ADDENDUM NO. 01
MACOMB COUNTY JAIL
LAUNDRY HOT WATER STORAGE
TANKS AND BOILER REPLACEMENT
Page 1 of 3 (write up only)

November 10, 2023

ADDENDUM NO.01 to the plans and specifications for the Macomb County Jail, Laundry Hot Water Storage Tanks and Boiler Replacement, Mt. Clemens, MI, Architect's Project No. 231997, dated October 25, 2023.

M0.00

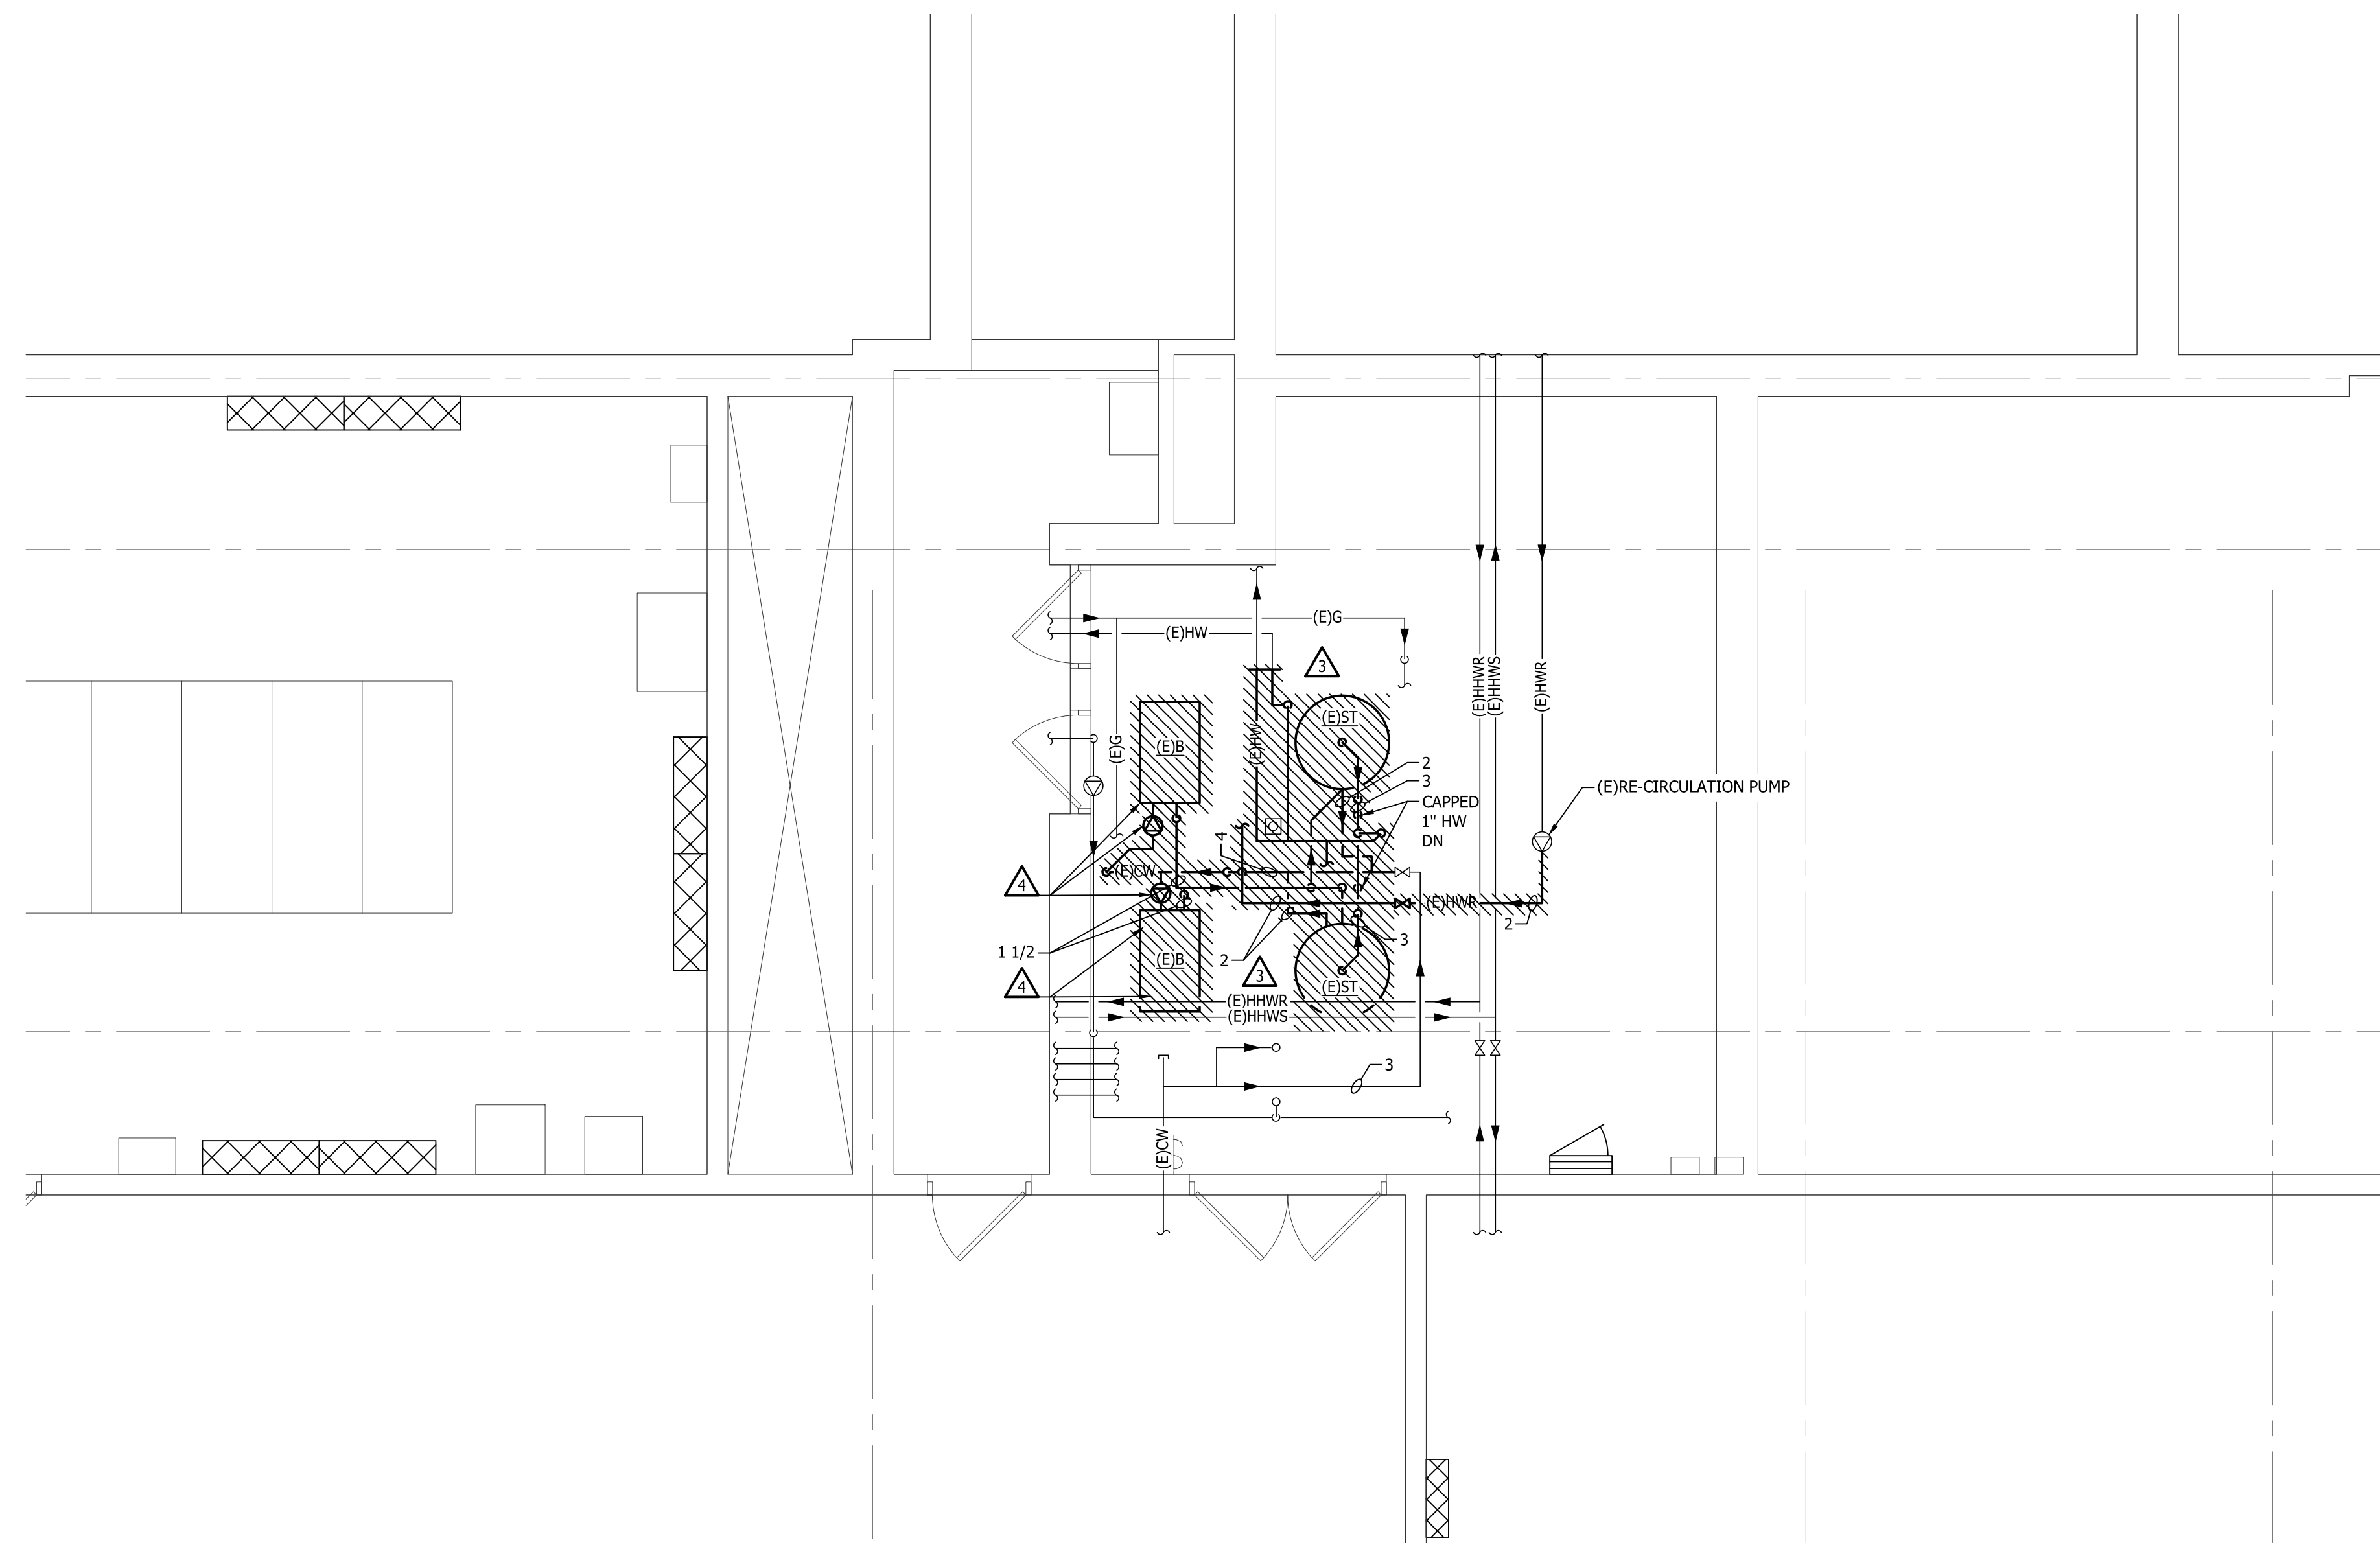
- ITEM NO. M1:** Refer to sheet M0.00 (Re-issued):
1. Add sheet M4.02 to the sheet List Table.

1
MDL01
ENLARGED MECHANICAL DEMOLITION PLAN
SCALE: 1/4" = 1'-0"

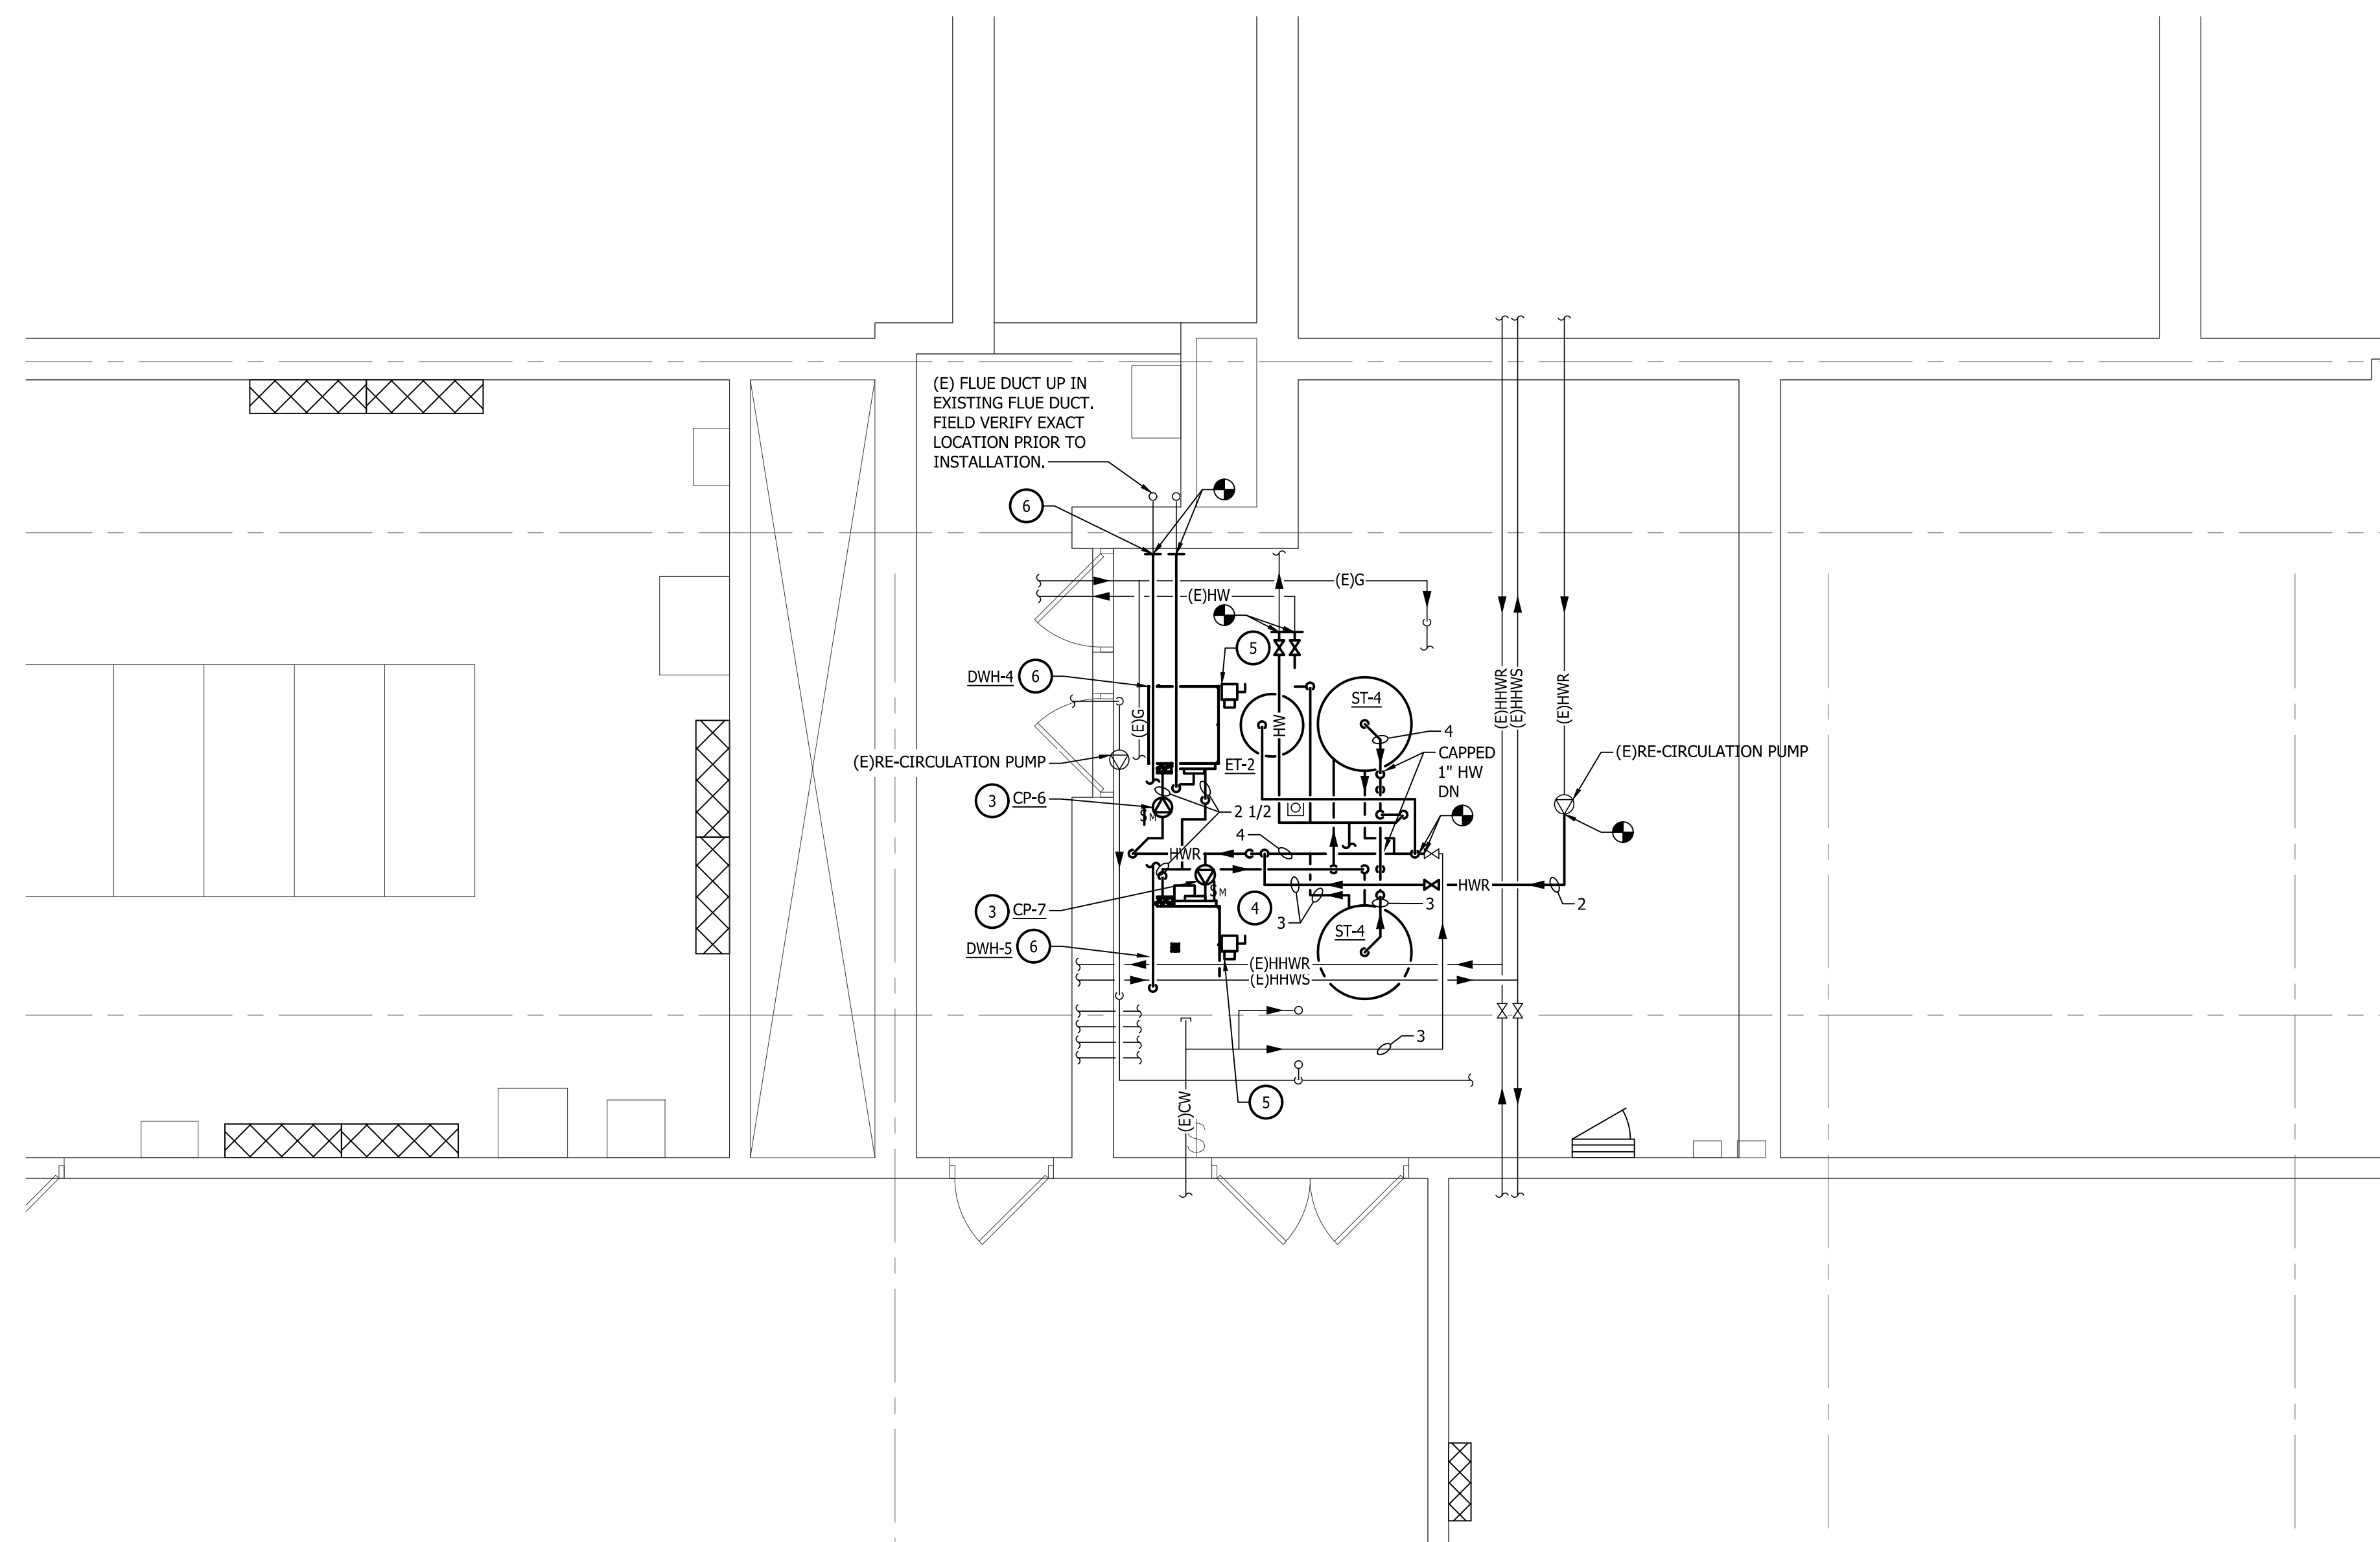
- ITEM NO. M2:** Refer to sheet M4.02 (Issued):
1. Add sheet M4.02 to the drawing set.

- ITEM NO. M3:** All work shown on ME4.02 is base bid. Hot Water tanks shown on ME4.01 are base bid. Boilers shown on ME4.01 are Alternate #2. .

6. Item #1: Drawing ME4.01 Demo Note #1- Indicates Alternate #1 (**This is now Alternate #2**) disconnect, make safe and remove existing domestic water heating boiler and all associated components complete.

7. Note #4 indicates to disconnect, make safe and remove existing domestic water heating boilers and associated pumps complete. **The boilers that are located on ME4.01 are to be as an Alternate (Alternate No. 2) to replacement. The Boilers that are located on ME4.02 are to be replaced base bid.**

8. Item #2: Drawing ME 4.01 Demo Note #2 indicates to remove circulation pump and all associated piping between boiler and storage tanks. Base bid pumps are to remain. Provide alternate pricing to remove and provide new pumps. What alternate is this? (**This is part of Alternate No. 2**)The bid form only indicates two alternates. Item #3: Bid Form indicates painting of the Boiler in alternate #2, please clarify what is to be painted in the boiler room. **Painting is clarified to be base bid now.**
